# SERVICE BULLETIN No BO-115/2022 SWIFT S-1

Inspection of front node in tailplane mount, and repair with modification – as necessary

# REPAIR/ MODIFICATION INSTRUCTION TAILPLANE FRONT MOUNT SWIFT S-1

Doc. No: A2-OR-01/2021

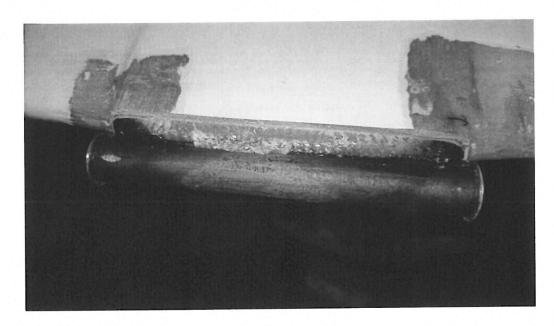
• the adhesive has been applied only under the central part of the tube with the fitting sleeves (manufacturing defect - no support under the sleeves),

Possible form of damage to the tailplane front mounting node.

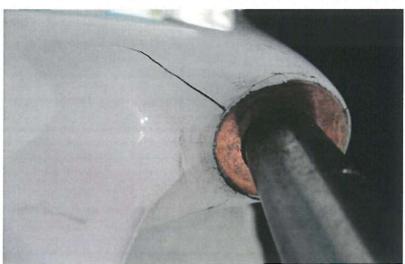
- 1. As one-time action, immediately upon receiving this Bulletin or when either detecting an excessive play at the tail mount fitting in ground inspection or encountering abnormal vibrations in flight,
  - and on a glider not modified as described below, also repeatedly at each 100-hour inspection inspect the tailplane front mounting node.
- 2. Inspect the concerned area for cracks on the outboard side of the composite console that supports the fitting sleeves and for the detachment / disbanding of the sleeves from the composite support. Check expansion of the crack gap, free movement of the fitting sleeves by moving (front/back up/down) the pin inserted into the sleeve.

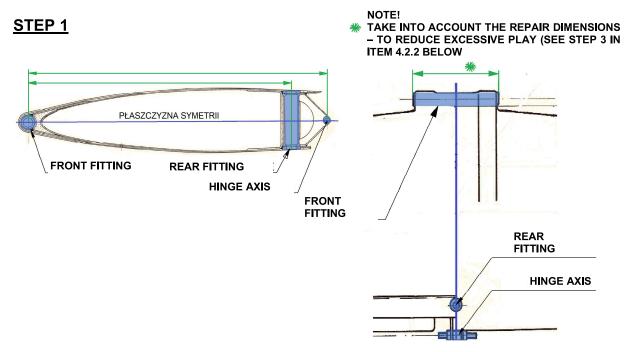
1. FABRICATE A RETAINER FIXING THE POSITION OF FRONT FITTING IN RESPECT TO ELEMENTS OF STABILISER /COMPONENTS OF SUSPENSION/ NOT AFFECTED BY REPAIR, TO MAINTAIN THE DIMENSIONS SHOWN IN THE ILLUSTRATION ABOVE

THE RETAINER TO BE PREPARED PRIOR TO ANY FURTHER ACTION IN STEP 2

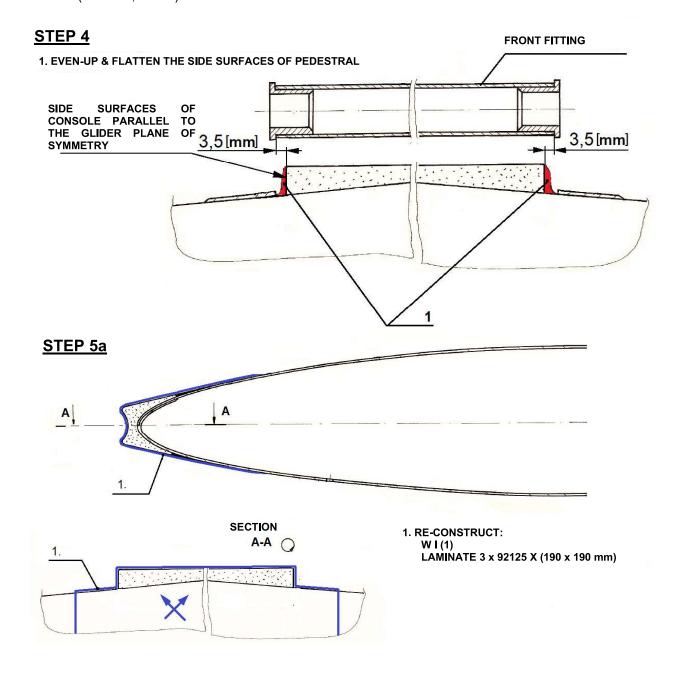
- DAMAGE
- EXCEEDING ALLOWED PLAY (Δ=0,10 mm)
- LACKING PROTECTIVE COAT BWF-21 (CONCERNS METAL COMPONENTS OF FITTING)

ORDER THE NECESSARY COMPONENTS AT PRODUCER, SPECIFYING REPAIR DIMENSIONS NECESSARY FOR CORRECT MATING

USING COMPONENTS WITH REPAIR DIMENSIONS REDUCE PLAY TO APPROX. 30% OF ALLOWED VALUE

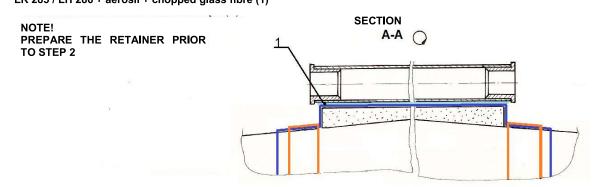
1. WITH AID OF THE RETAINER (SEE STEP 1), PREPARED INDIVIDUALLY FOR THE CONCERNED S/N PRIOR TO FURTHER STEPS, BOND-IN THE METAL FRONT FITTING WITH COMPOSITION:

LR 285 / LH 286 + aerosil + chopped glass fibre (1)

#### STEP 7a

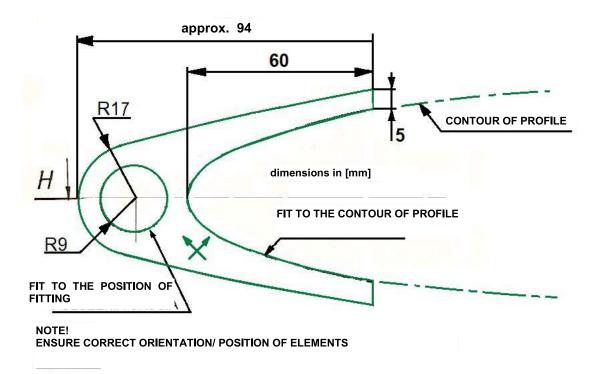
1. LAMINATE 2 RIBS, ACCORDING TO THE SKETCH BELOW

**FABRICS LAYOUT: 8 x 92125 X**

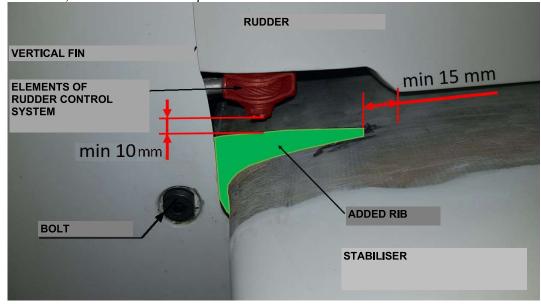
# NOTE! ENSURE SAFE CLEARANCE BETWEEN ADDED RIB AND COMPONENTS OF RUDDER ACTUATION, TO AVOID COLLISION BETWEEN MOVABLE ELEMENTS. SEE ILLUSTRATION BELOW

#### STEP 2

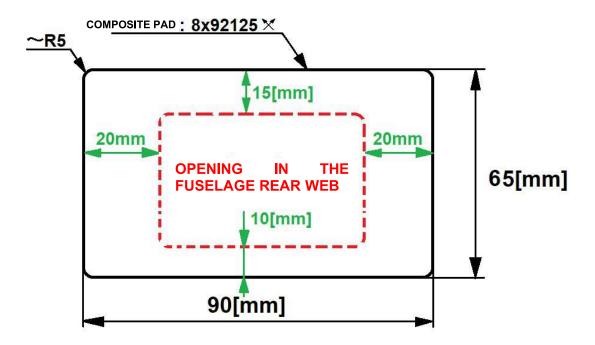
Laminate on flat surface the composite reinforcing pad, with a contour as shown in the sketch below, adjust dimensions to the size of opening.

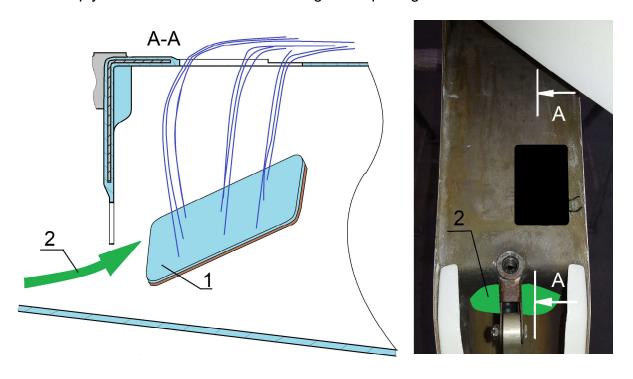
To press the reinforcement against the rear web, use strings of 500 mm length – arrangement of string see sketch below.

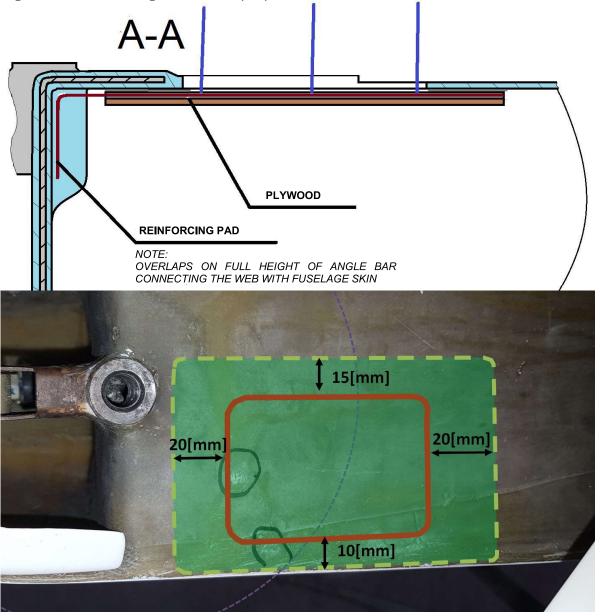
In accordance with the sketch below, bond in the reinforcing pad with composition: LR285 + LH286 + aerosil + chopped glass fibre

Tighten with the strings to ensure proper connection.
